Matchanese Mall of Asia

Feedback on Design Proposal

Design Consideration - Visual Focus

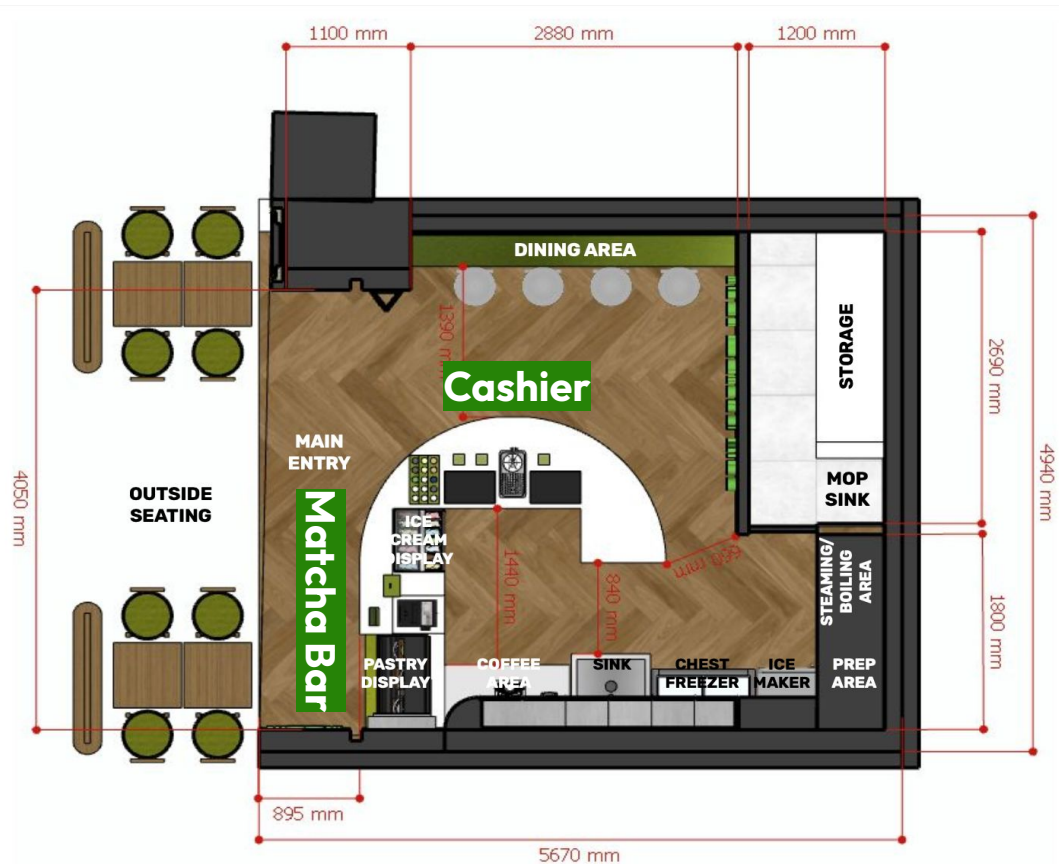
- From the proposed design, it looks **visually busy** – mixed materials, decorative elements, wood, grids, plants, signage and textures all competing for attention making the space look cluttered
- The **product should stand out** when put in front instead of blending into the scene

- The layout should have a more cohesive design language and intentional forms with function

Proposed Design Feedback - Layout

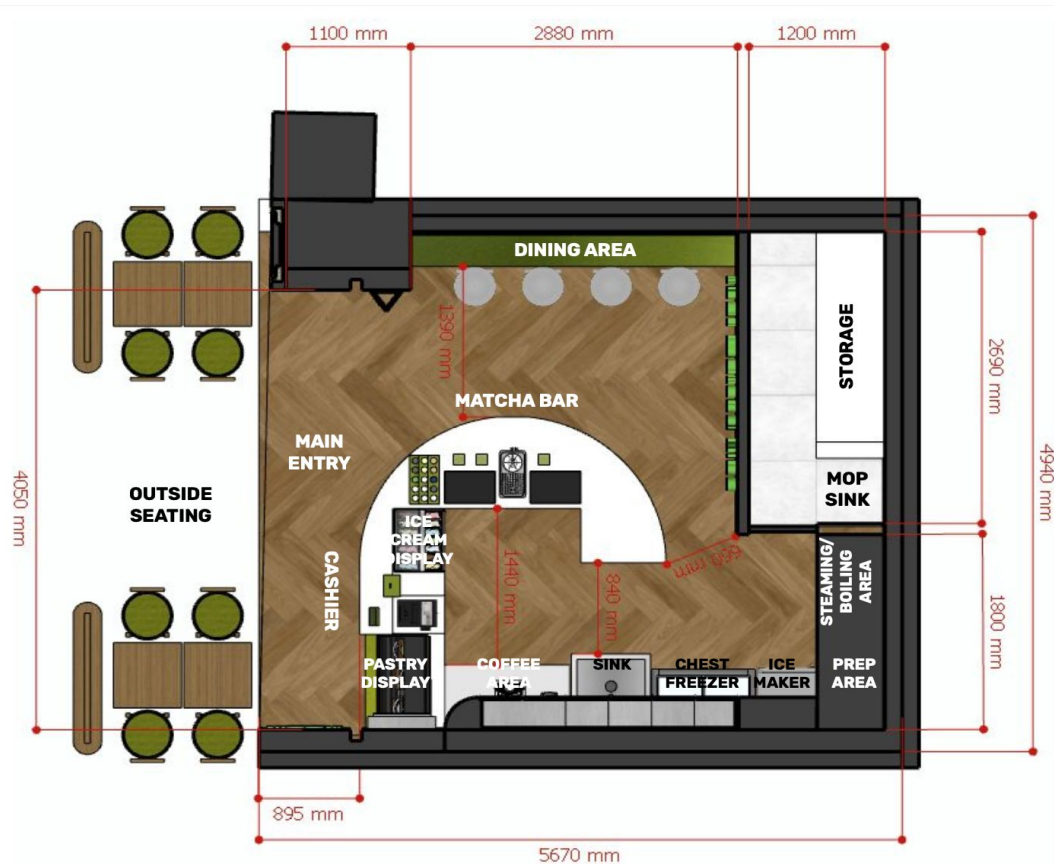
- The Matcha Bar would be better on the front side as it is a showcase of how all our drinks are made. It should be the first thing that passersby from the outside see instead of the cashier
- Since the store opening is in the center, customers queueing up would have a straight line from the outside towards the cashier

Proposed Design Feedback - Layout

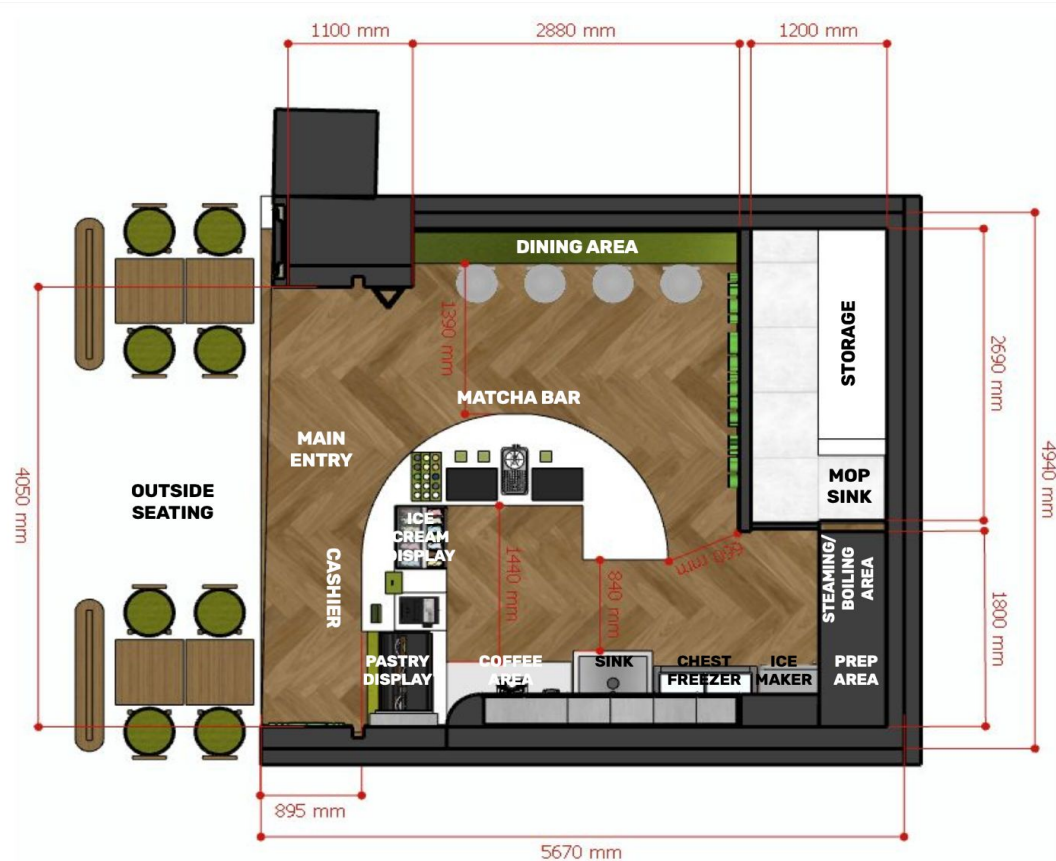
- The circular design was initially suggested as it can work when executed well and be a memorable form
- In the proposed design, however, it being a half-circle and hidden inside kind of loses the visual impact.
- A lot of space which could be additional counter space is wasted because of the large curvature.
- From the proposed layout, it might be better to make the the counters more straight and with a smaller corner radius. Also extend it to hide the gap where the staff enters
